Arborist Site Inspection Impact Assessment

Client:	Kosciuszko Thredbo, Mr. Euan Diver
Date of inspection	22 Oct 24
Address	Village Green, Friday Drive THREDBO NSW
Arborist completing inspection:	Andrew Downing Senior Arborist Assess Trees at AQF 5, QTRA Licenced User

A request from Euan Diver was received to inspect two trees located on the edge of the village green and inside the children's playground area for the impact to tree health from proposed storm water trenching work.

Typical TPZ and 10% encroachment detail

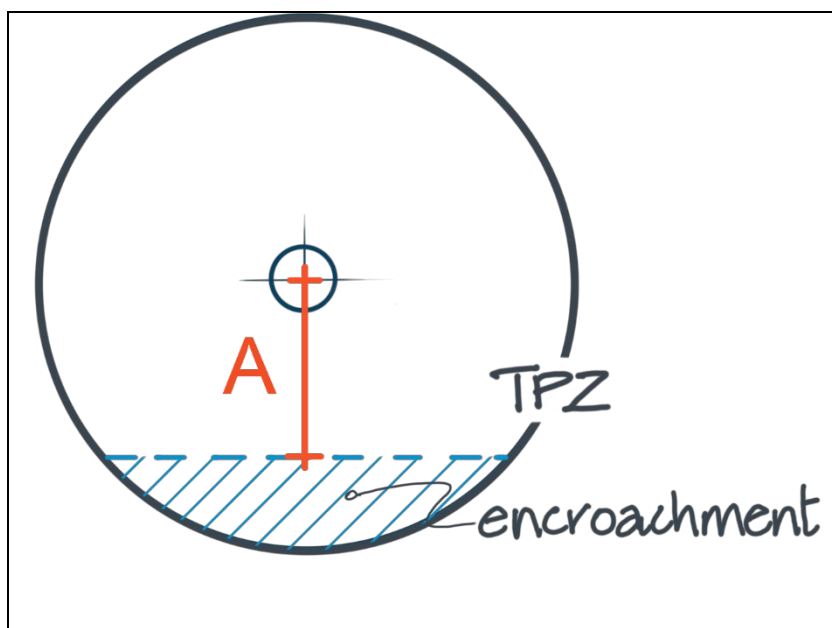
There are proposed trenching works planned to upgrade the storm water service from the village green that will be directed between the two trees and approx. 6m from both trunk bases. See attached image.

Any encroachment by trenching into the Tree Protection Zone (TPZ) that will cause damage to tree roots will have a negative impact on tree health and should be avoided. While a ten percent encroachment is permissible anything above this should be avoided. Any encroachment over thirty percent can cause partial decline or whole tree death.

Distance (m) for minor encroachment (10%)	9.3
Distance (m) of trench line from trunk centre	3.0
TPZ radius (m)	13.6
SRZ radius (m)	1.5
TPZ area (m ²)	578.7
Encroachment area (m ²)	208.6
Encroachment (%)	36.0

Distance (m) for minor encroachment (10%)	5.8
Distance (m) of trench line from Trunk Centre	3.5
TPZ radius (m)	8.4
SRZ radius (m)	3.0
TPZ area (m ²)	221.7
Encroachment area (m ²)	53.8
Encroachment (%)	24.3

The proposed line of excavation through the TPZ of both trees exceeds the permissible encroachment allowance of 10 percent.

A solution to this should include planning for minimal impact excavation techniques such as Hydraulic Vacuum Excavation using high pressure water to cut through soil and vacuum suction to remove liquid debris or careful hand excavation. Any tree roots encountered must be avoided and left undamaged. Minor roots less than 20mm diameter may be cleanly cut using loppers or a hand saw.

Backfilling of trenches post works should be done using washed river sand and watered in to ensure any air pockets are completely filled.

The area beneath the trees and inside the TPZ should be mulched with organic mulch to a depth of 100-150mm.
